## Accessibility Survey

## City of Downey Fidler Avenue - Angell Street To Foster Road

Date of Inspection  
12/3/2016

Prepared By  
**Disability Access Consultants**  
(800) 743-7067

#### Change In Level South Of Angell Street @ 33.911933035896, -118.131414502859

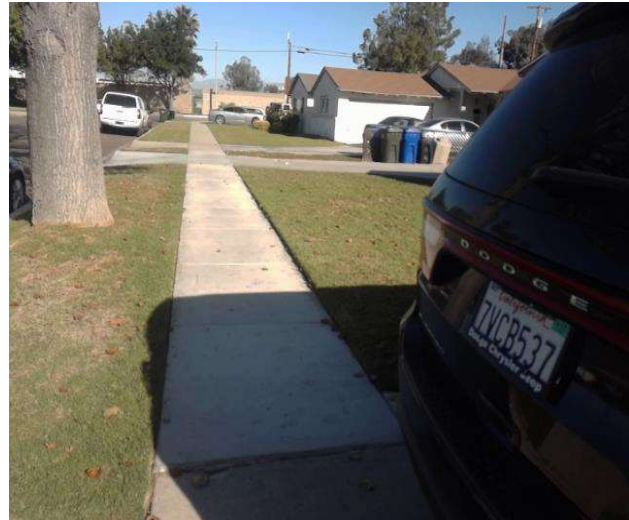
Sidewalks , Change in Level : Change in Level Non Beveled

There is a change in elevation greater than recommended value.

**On-Site Finding** 1.00 inches

**Code Reference** ADA 206, 302

Ensure that the change in elevation is within the recommended value.

Recommendation Up to 0.25 inches
